**Project Addendum 1**

Project: FY22 Street Paving

Date: January 31, 2022

## TYPICAL RAISED CROSSWALK DETAIL

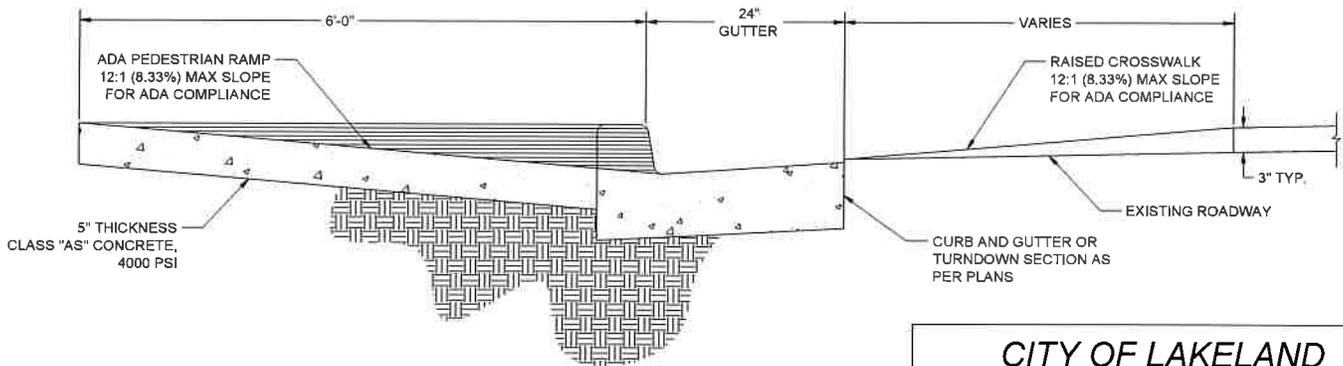
11. Standard Detail "Typical Raised Crosswalk", replaced "Standard Crosswalk Pavement Markings" with "Crosswalk to be colored red stamped with brick pattern"
